**CLEAN ENERGY ASSOCIATION OF B.C.
(CEABC)**

**COMMENTS ON BCUC'S ALTERNATIVE PORTFOLIOS
TO
THE B.C. UTILITIES COMMISSION**

**2017 INQUIRY RESPECTING
THE SITE C PROJECT**

OCTOBER 18, 2017

Figure 2: Annual GHG emissions of the Site C Project'

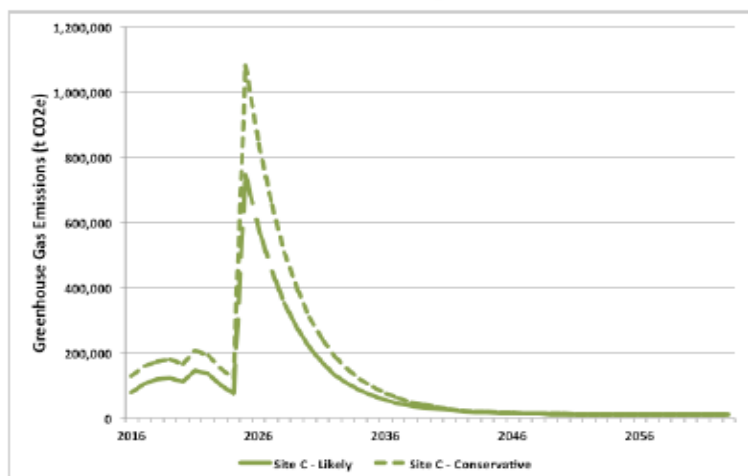
The following chart, taken from Exhibit F106-4 (page 82 of 138) shows that the greenhouse gas emissions from Site C will be extremely high in the first few years, as the methane escapes from the rotting vegetation/overburden in the reservoir.

Figure 3: Cumulative GHG emissions of the Site C Project⁸

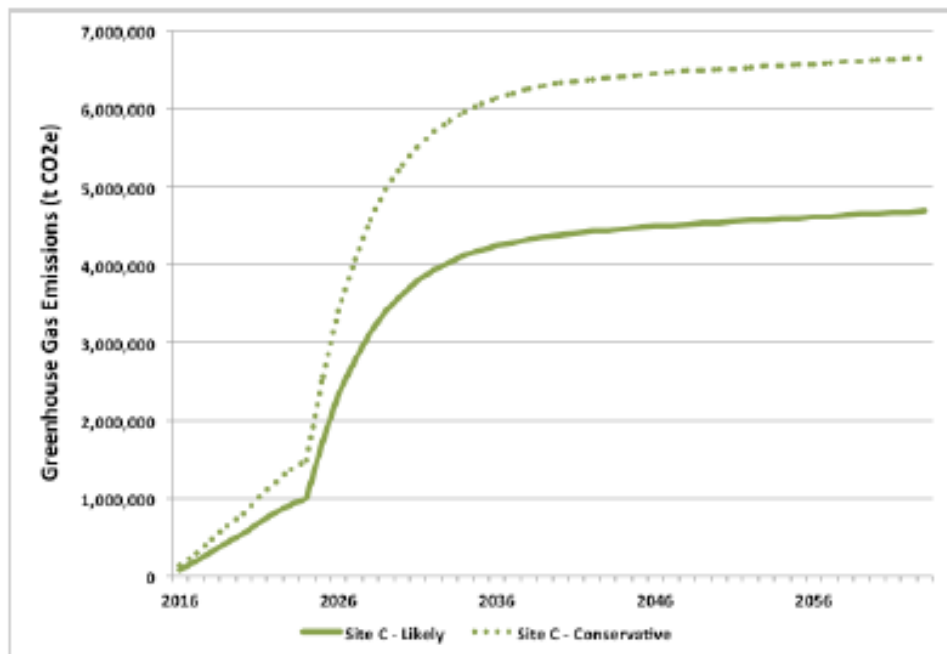
The cumulative emissions reach 4 to 6 megatonnes within the first 8 years of operation, as shown on the following chart (F106-4, page 84 of 138):

If SCGTs were to be used as the backup choice for the first 10 or 15 years, they could easily operate within the limit of emissions set by Site C. As a peaking/backup resource, they only need to operate about 3% of the year, at which rate there would only be about 50 kilotonnes/year of CO2e from 400 MW of SCGT backup. This could be carried on for up to 80 years without exceeding Site C's emissions.
